DRAWINGS – REVISION 1

DMVA PROJECT NO. 42230136 For BUILDING 16-153 RENOVATION

'REVISION 1' includes the following drawing sheets and notes.

REFLECTED CEILING PLAN

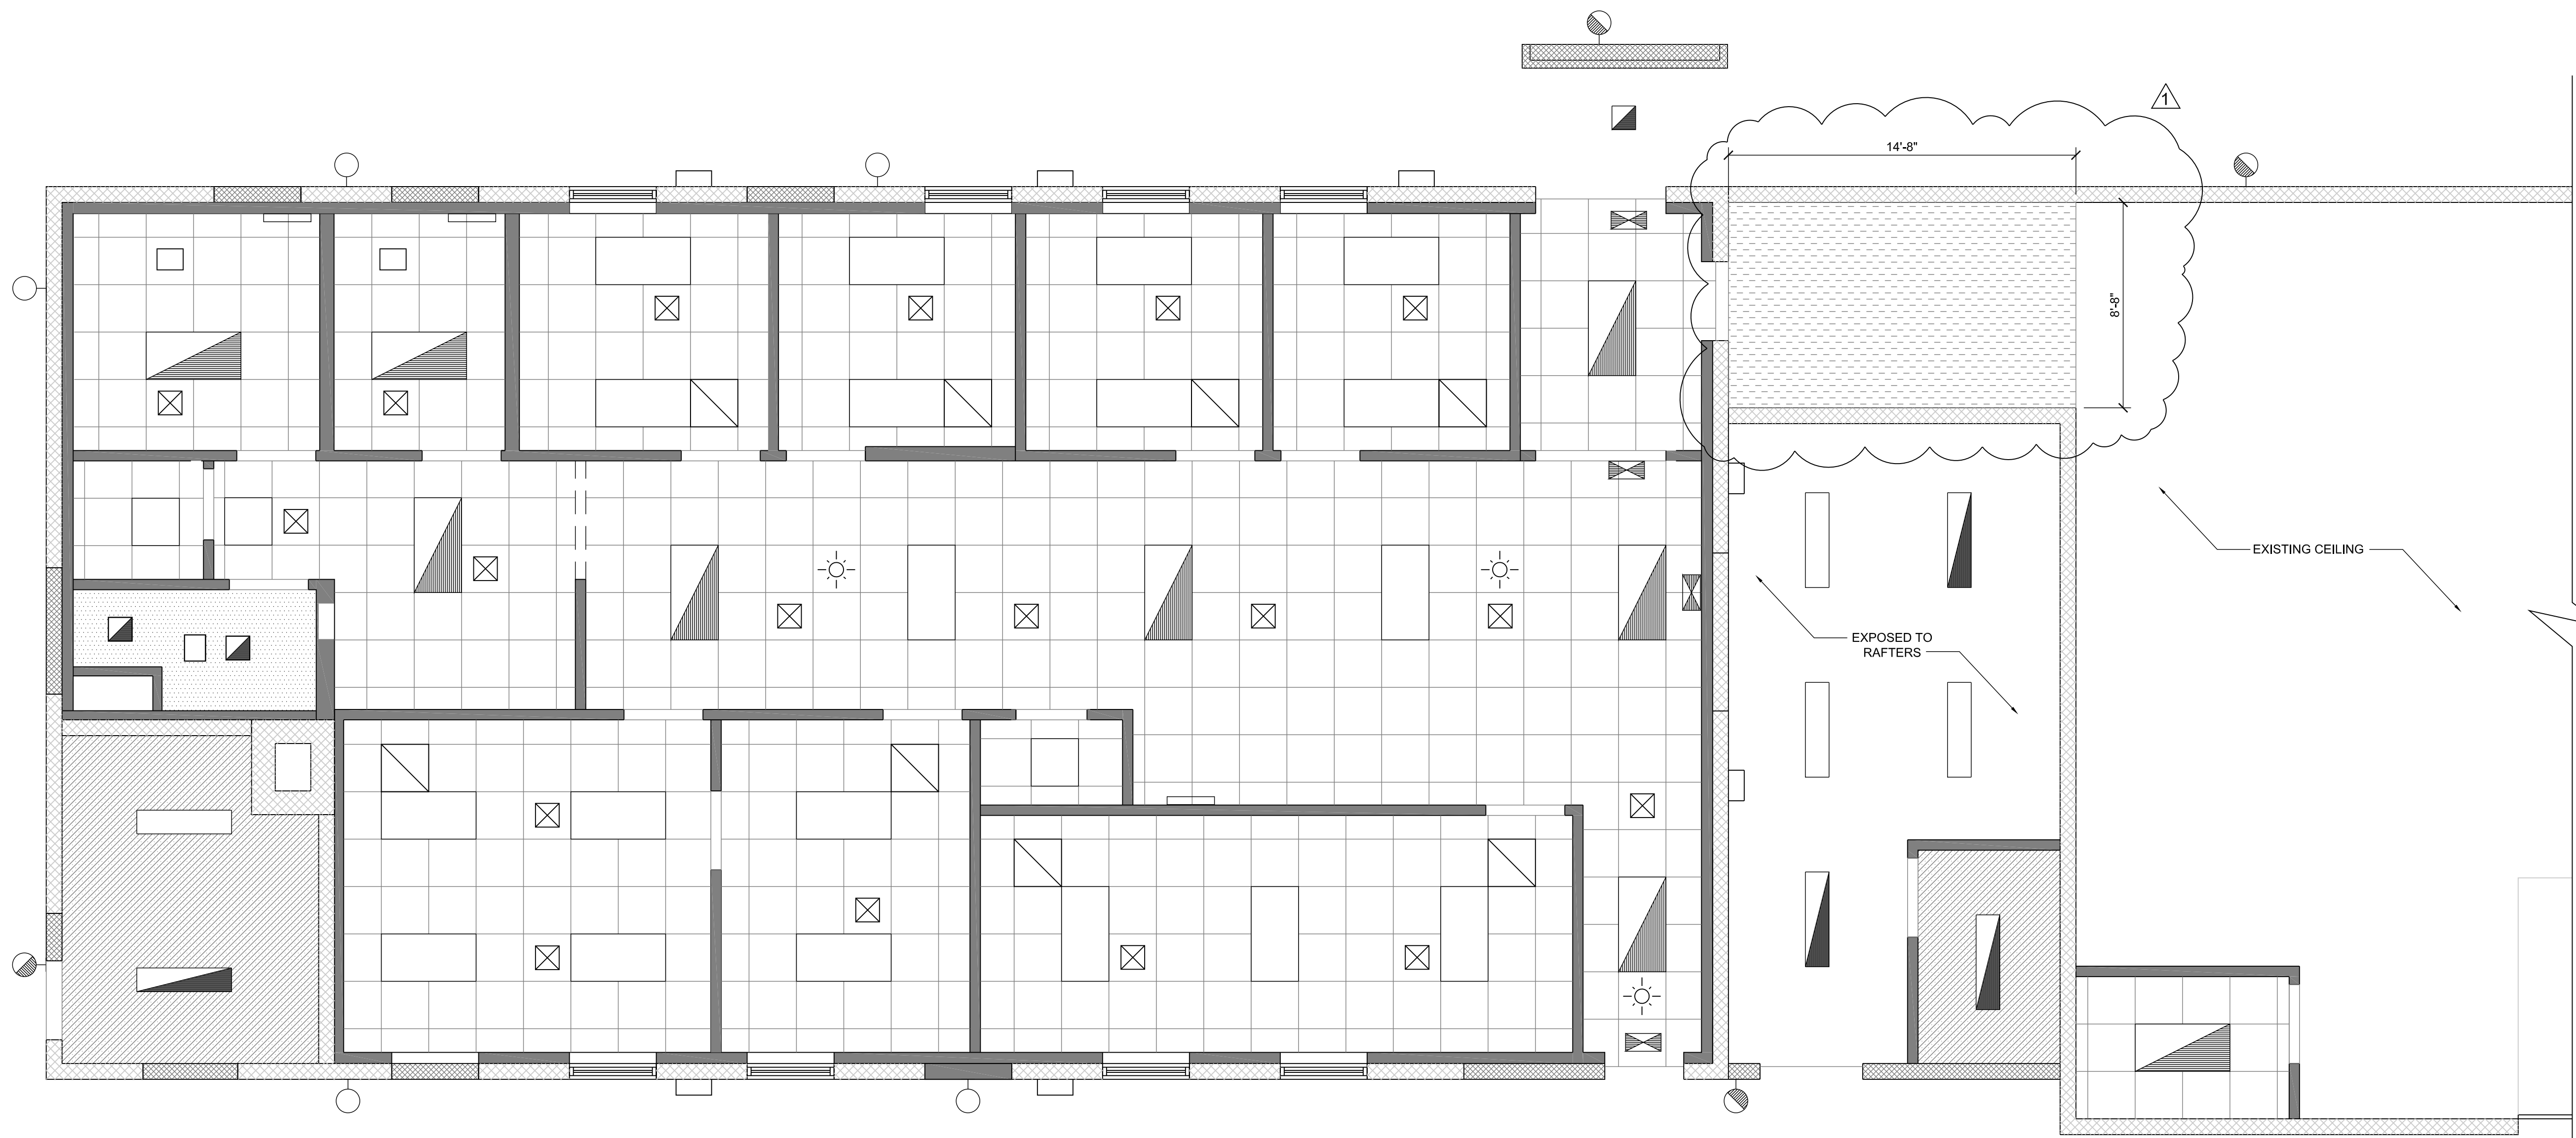
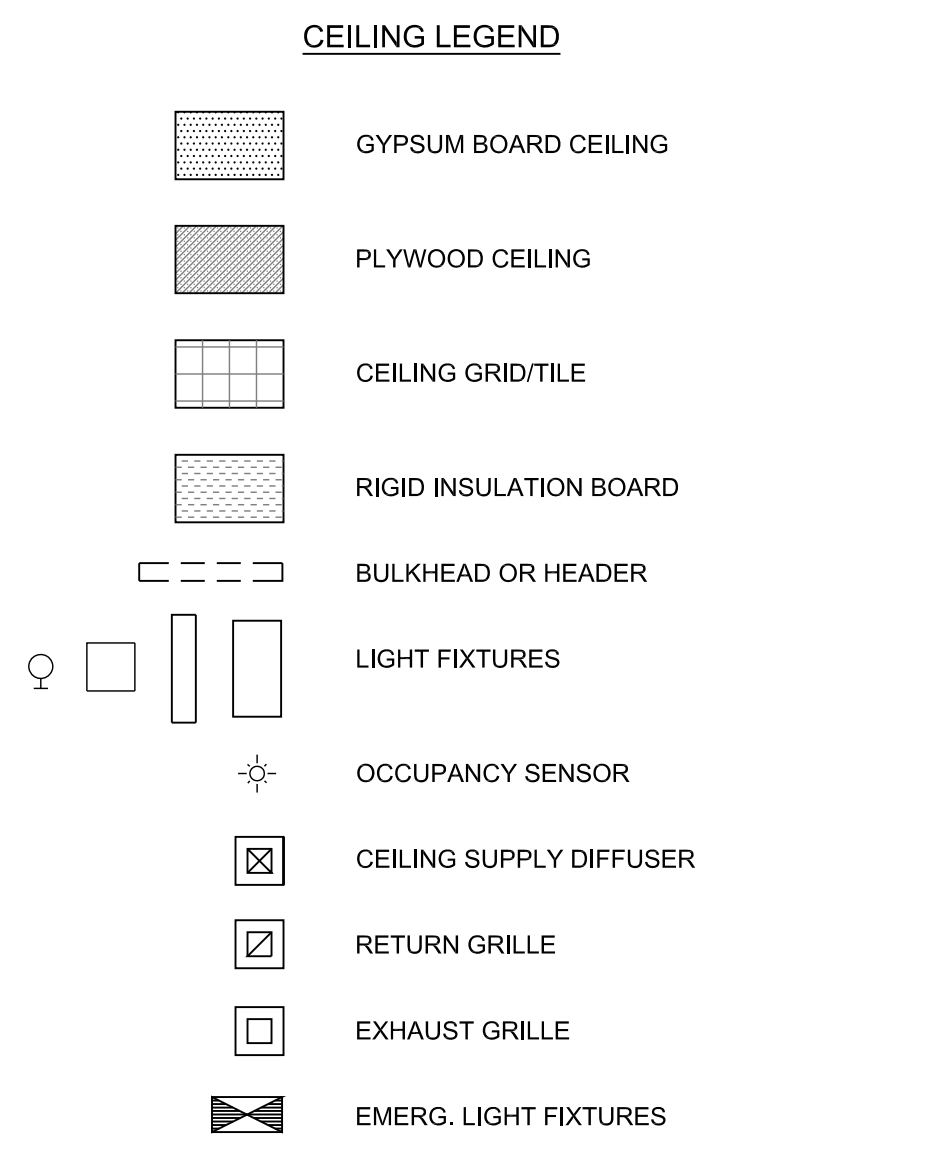
NO.	DESCRIPTION	DATE
1	ADD. CEILING AREA	5 APR 24

ROOF PLAN

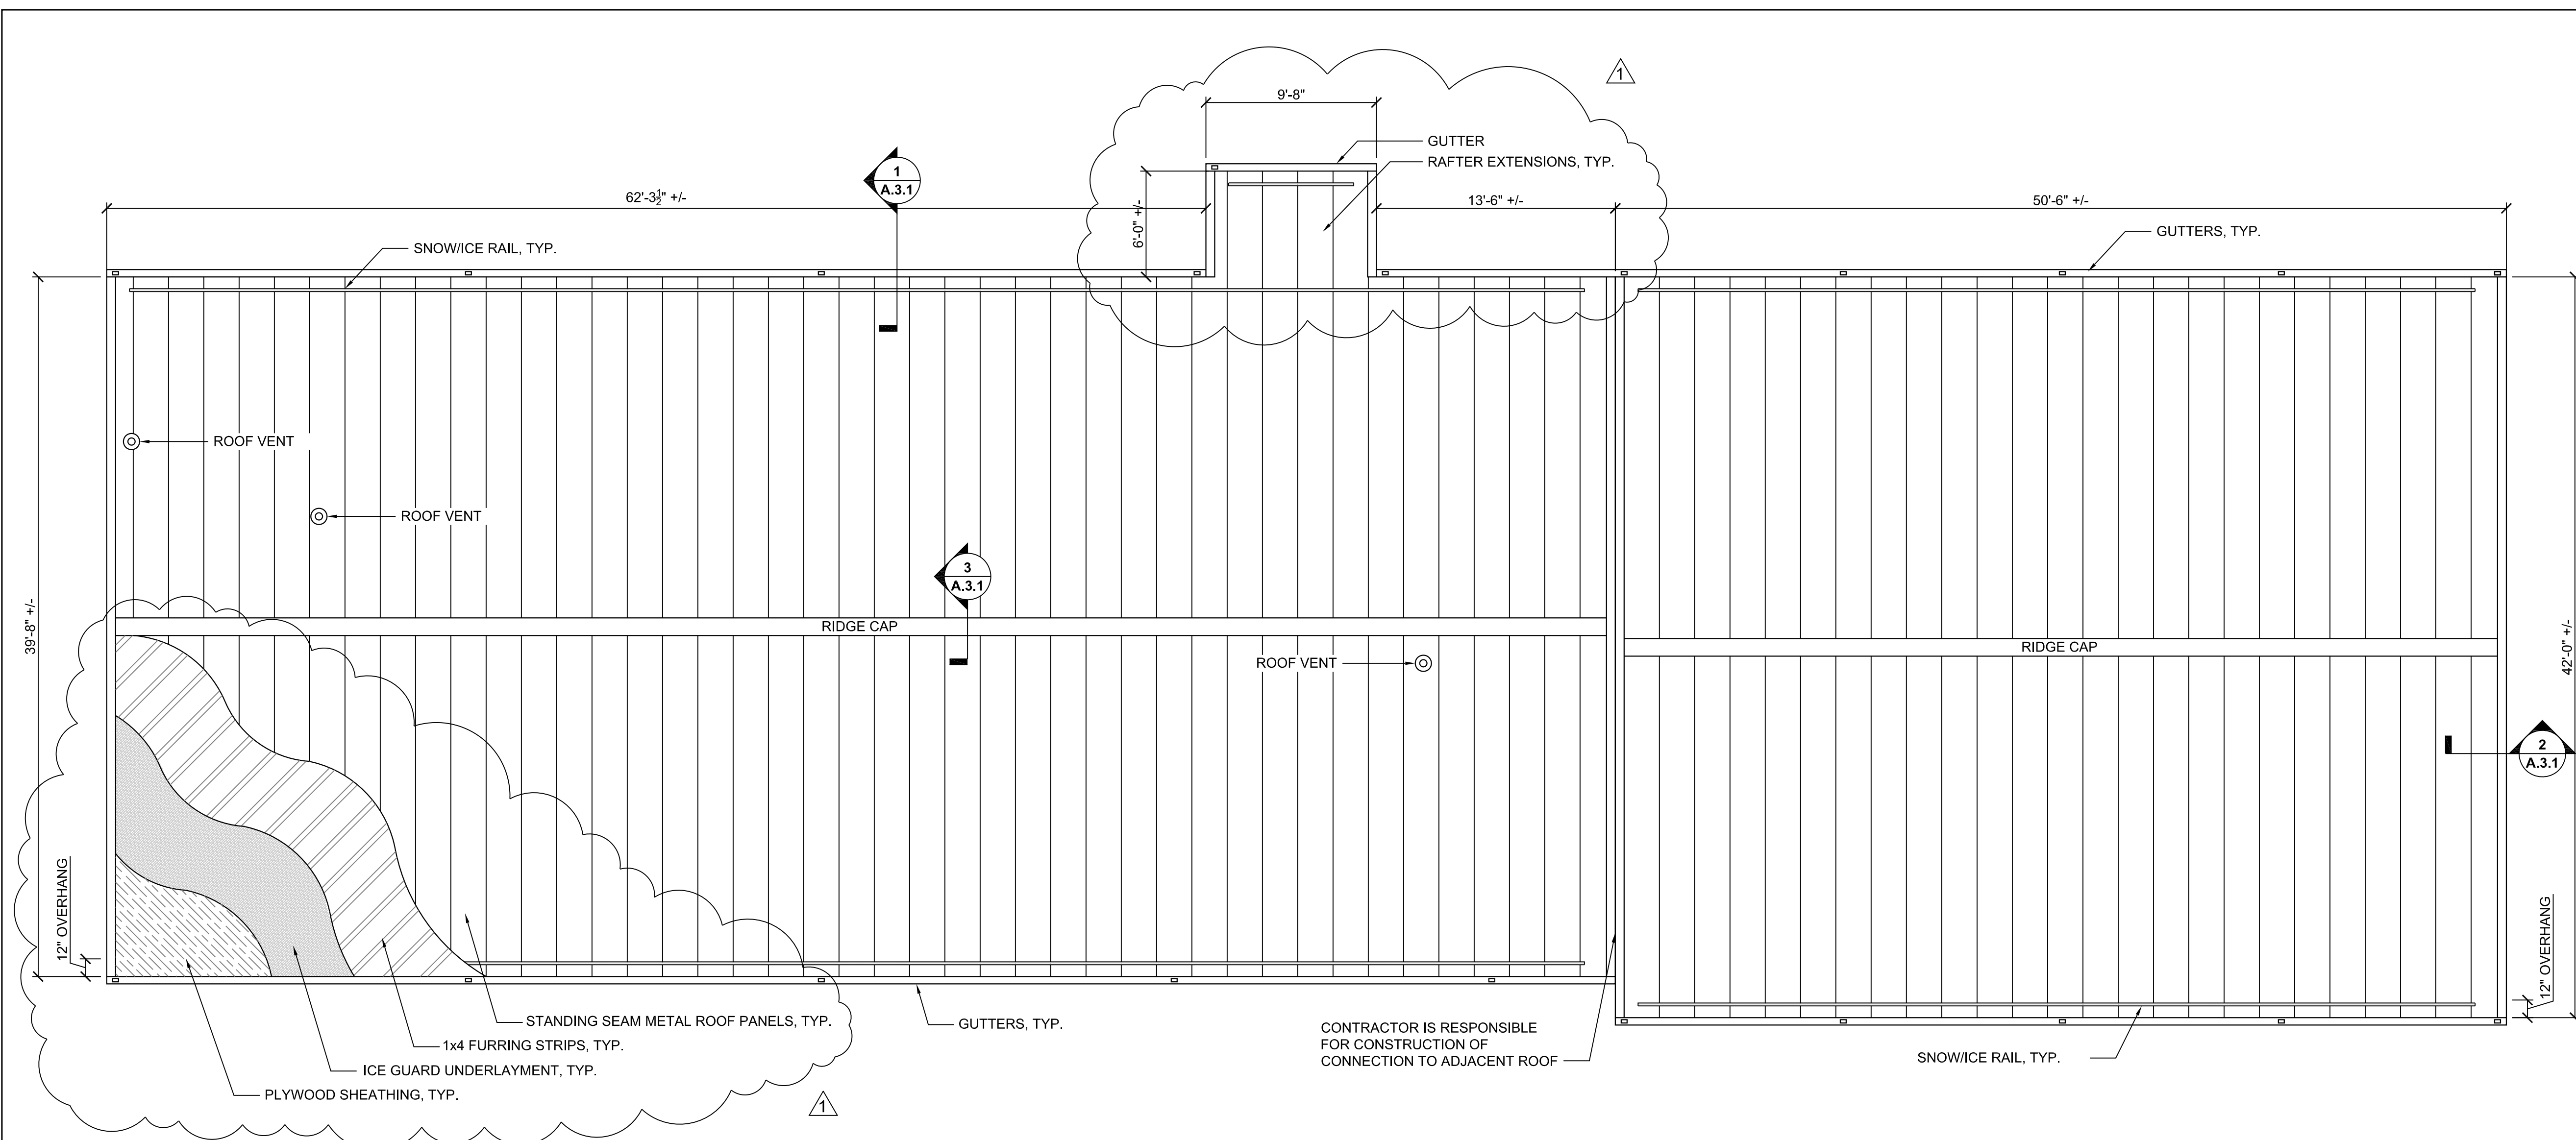
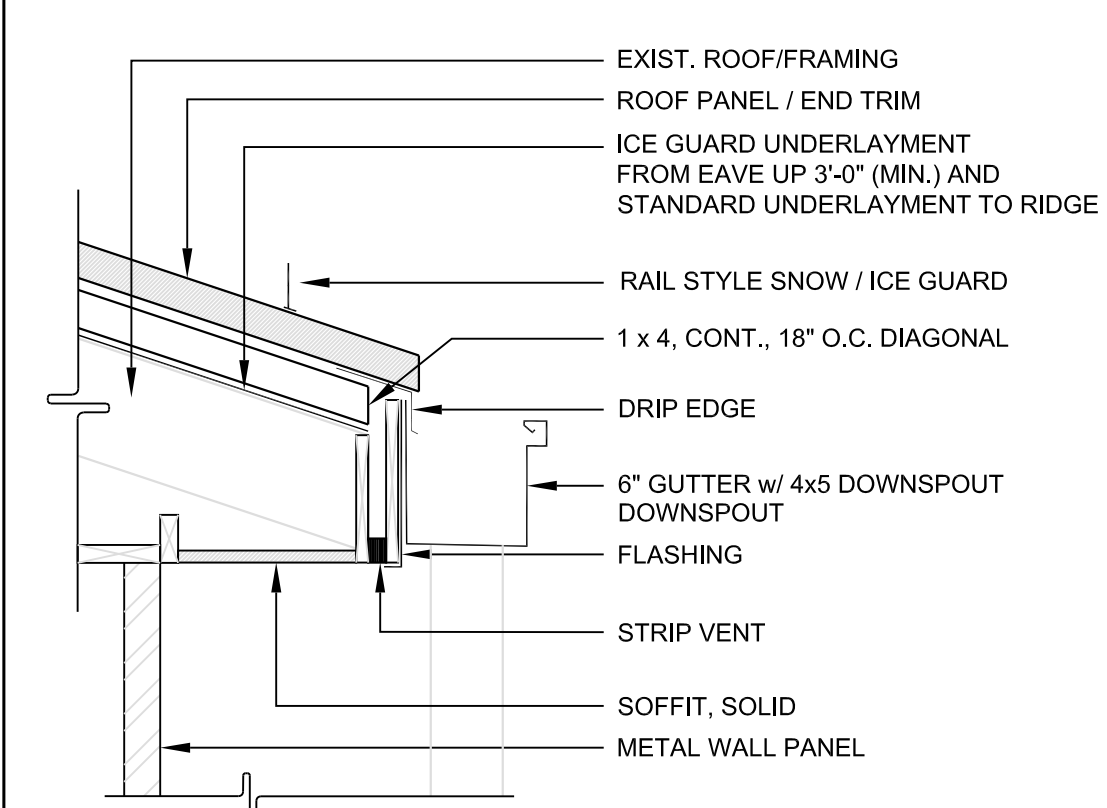
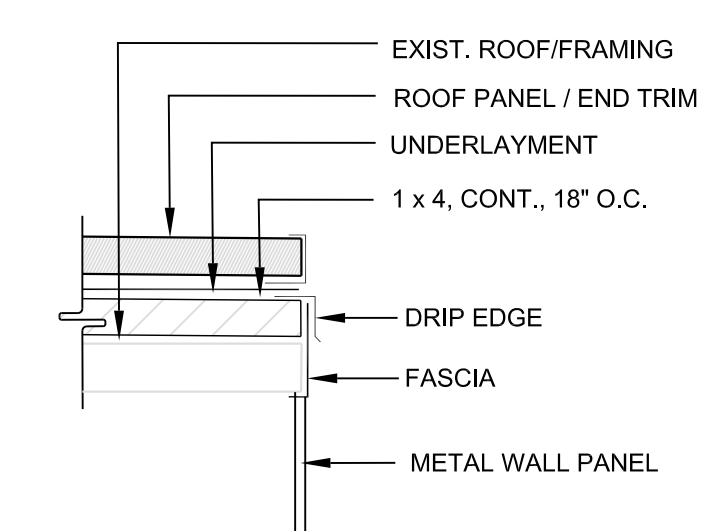
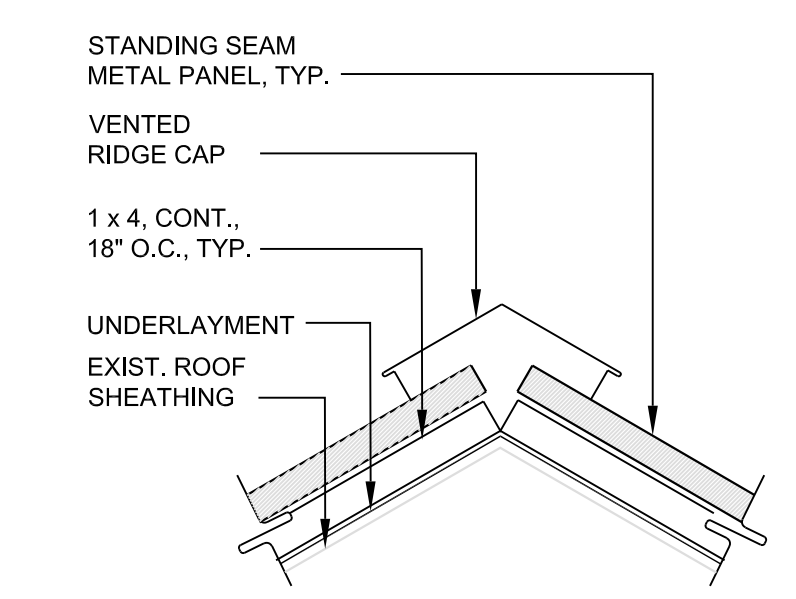
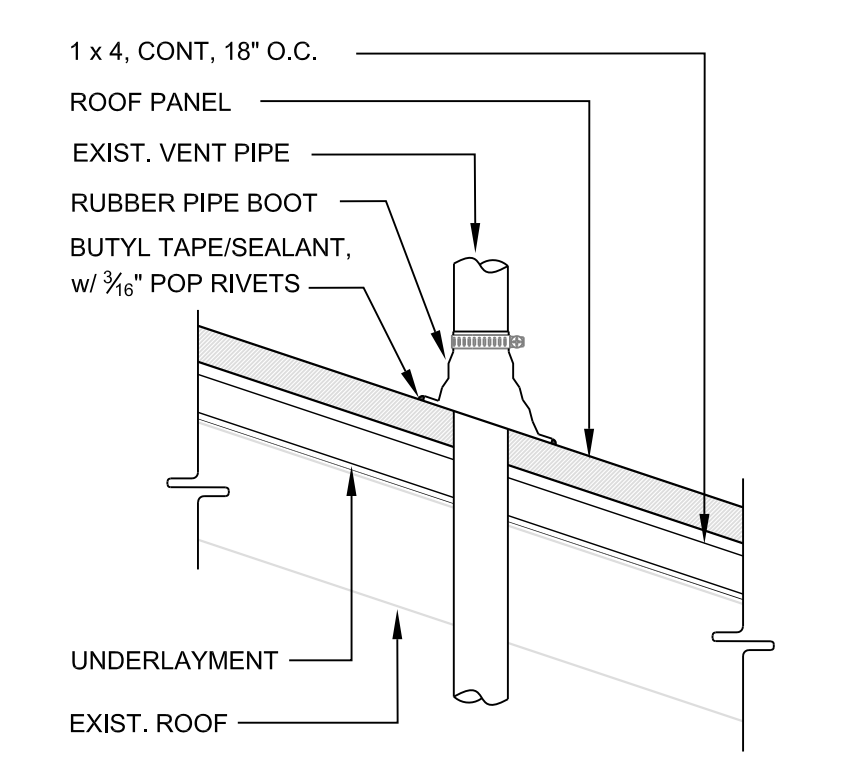
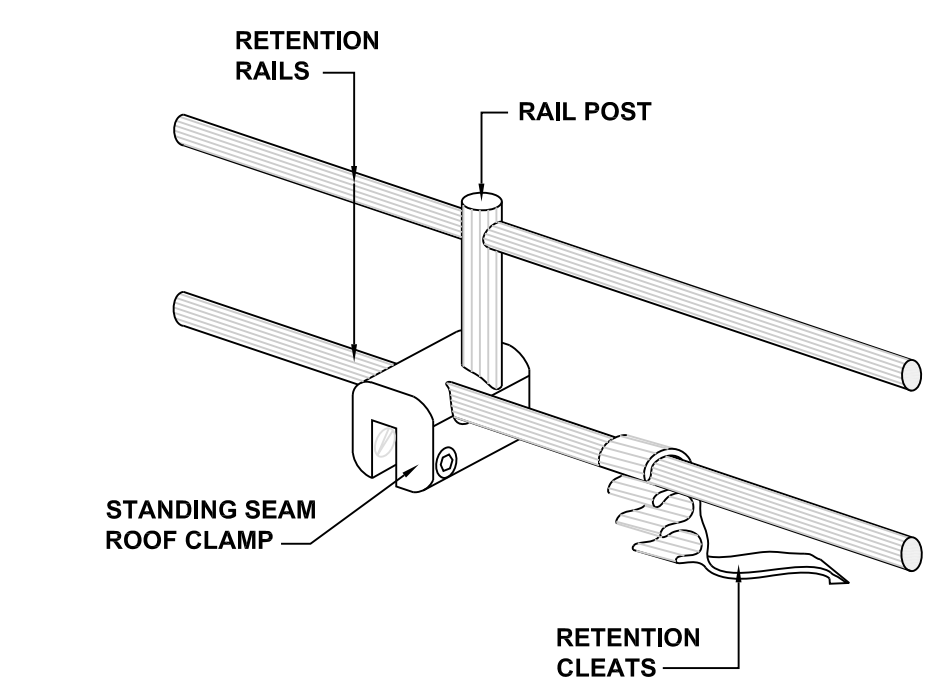
NO.	DESCRIPTION	DATE
1	REVISED DETAIL, DIMENSIONS, NOTES	5 APR 24
